REMARKS

Amendments to the Drawings:

Annotated sheet

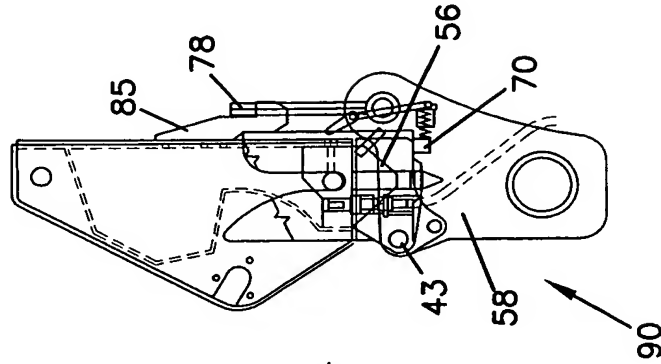
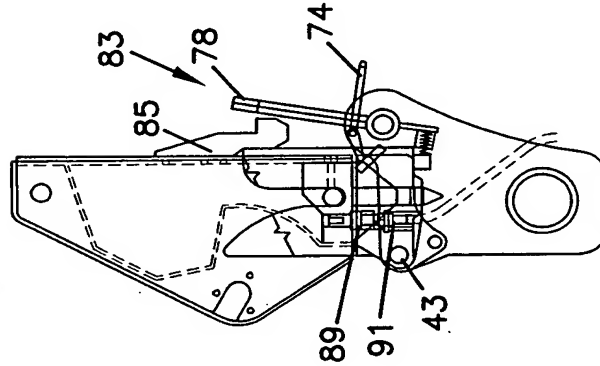
The outstanding Office Action states that it is "unclear how the lock structure operates." Figs. 6a-6d show, in the context of the specification at page 12, line 21 through page 13, line 17, how the rotating bracket 42 rotates relative to the stationery bracket 41. As the rotating bracket 42 rotates into the stationery bracket 41, the receiver hook 85 moves the catch 78 and becomes locked in place as shown in Fig. 6d. The catch 78 includes an opening through which the receiver hook 85 moves to engage the catch 78. The opening in the catch 78 is shown by the solid line. The Examiner may have difficulty discerning this from the side view provided in Figs. 6a-6d. Nevertheless, the opening is present in the catch 78 to receive the receiver hook 85. The lever 74 is provided to move the catch 78 away from the receiver hook 85 in order to disengage the catch from the receiver hook 85. For example, the lever arm 74 can be raised so that the catch 78 moves away from the receiver hook 85. This is shown by, for example, going from Fig. 6d to Fig. 6c. The operation proceeds in a reverse manner going from Fig. 6c to Fig. 6d. The lever arm 74 can engage the tab 76 to push the catch 78 away from the receiver hook 85. Accordingly, it is submitted that it is clear from the disclosure in the specification and Figs. 6a-6d how the lever 74 provides for the movement of the catch 78 away from the receiver hook 85 in order to release the rotating bracket 42 from the stationery bracket 41.

FIG. 6b

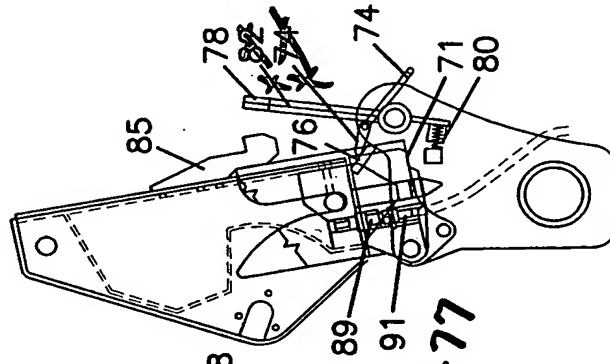
Fig. 6b has been amended to remove the second occurrence of reference number 74.

Fig. 6b has been amended to remove reference number 82.
